STANDARD GROUP LIMITED

Plot No.-10300, Building -1 and building -2(4,5,6) Floor, Beraiderchala,
Post-Gilaberaid.; Sreepur PS; Gazipur-1740; Bangladesh.

13 November 2023

2. Observations

Observation-1: Inconsistency in compressive strength of concrete (Main Production Building).

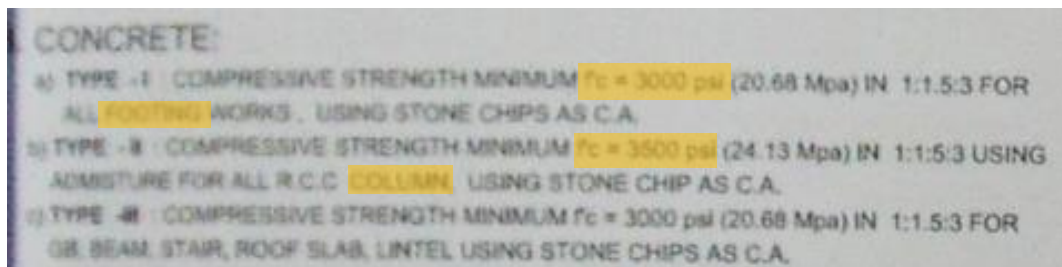
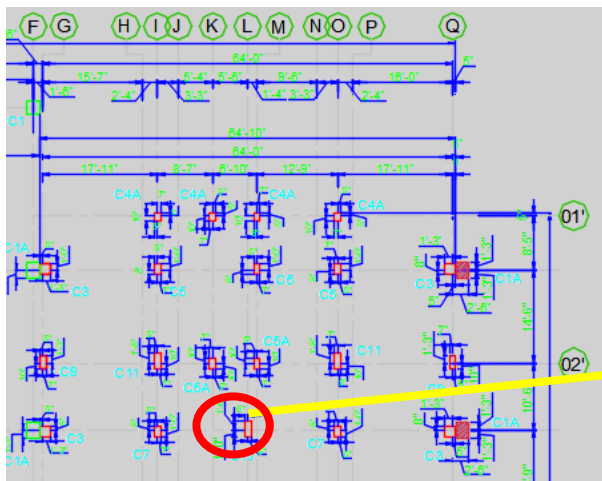
Description: In design report, compressive strength of concrete has been considered as 4000 psi for footing and column but in construction drawing 3000 psi and 3500 psi were mentioned for footing and column respectively. In addition, the available test results are insufficient to meet the evaluation and acceptance criteria of BNBC. The building engineer is required to evaluate concrete strength as per BNBC, revise design report accordingly and submit to RSC for review.

Mismatch in column orientation at grid L-3 (both block A & B)

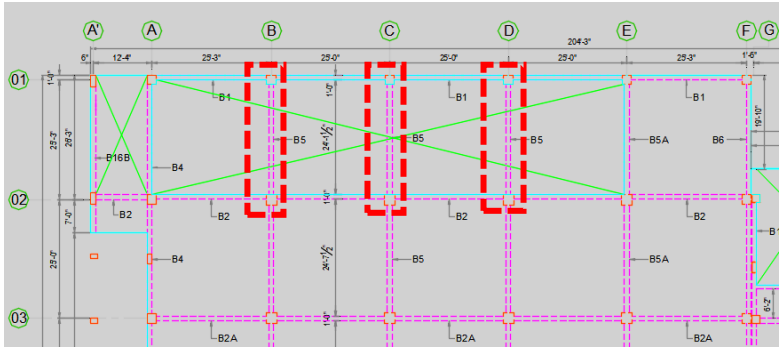
Description: During inspection, some mismatches (column orientation, steel beam instead of RCC beam at roof level, 150 mm buildup at toilet area, partition wall layout etc.) were found between onsite condition and as-built drawing. The building engineer is required to survey the full structure, update as-built drawings as per site condition and incorporate in assessment.

Observation-5: Discrepancy in as-built drawing (Washing Building).

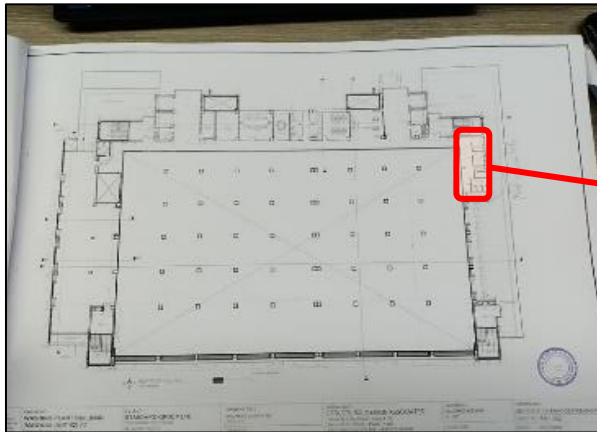
Description: A monorail crane was found in the ground floor column. But in as-built drawing it was not mentioned.

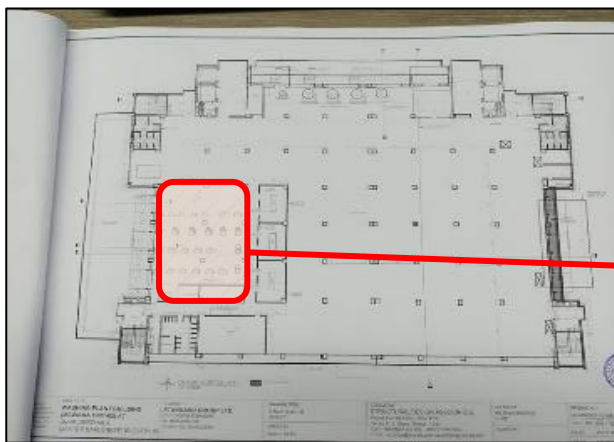
Description: Toilet layout at North-East corner was not matched with as-built drawing.

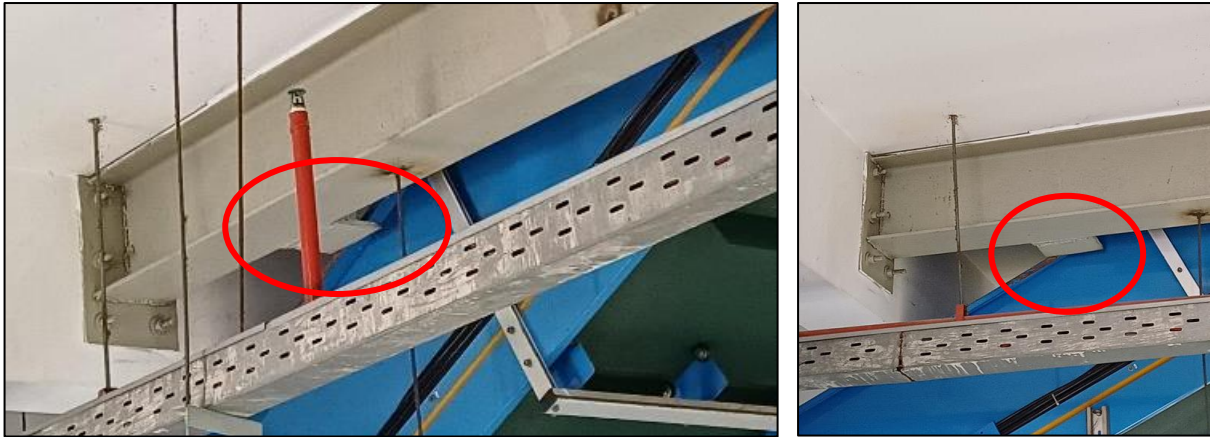
Description: 5 nos. circular column was found only on the 5th floor. But in as-built drawing circular column was mentioned from base to roof.

Observation-12: Absence of concrete compressive strength test result (Utility Building).

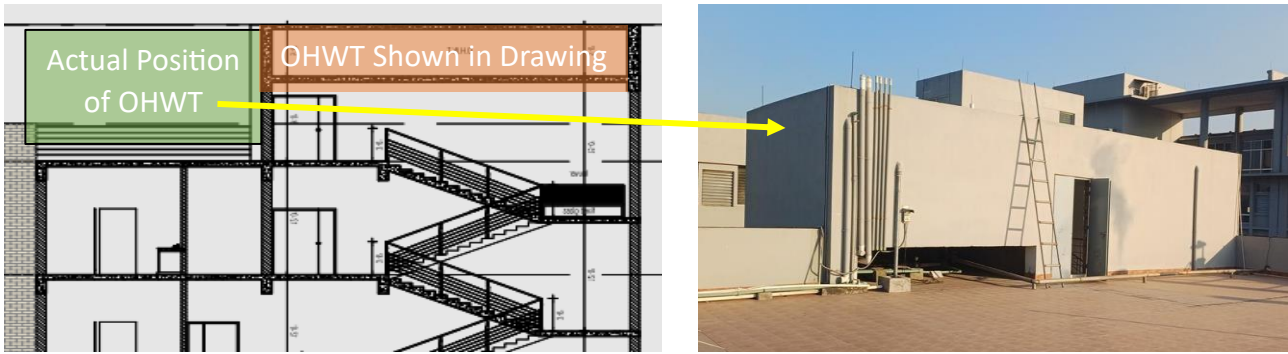
Description: In design report, compressive strength of concrete was considered as 3500 psi for column & footing and 3000 psi for beam, slab etc. But no concrete compressive strength test result was available onsite. The building engineer is required to verify in-situ material strength, produce design report accordingly and submit to RSC for review.
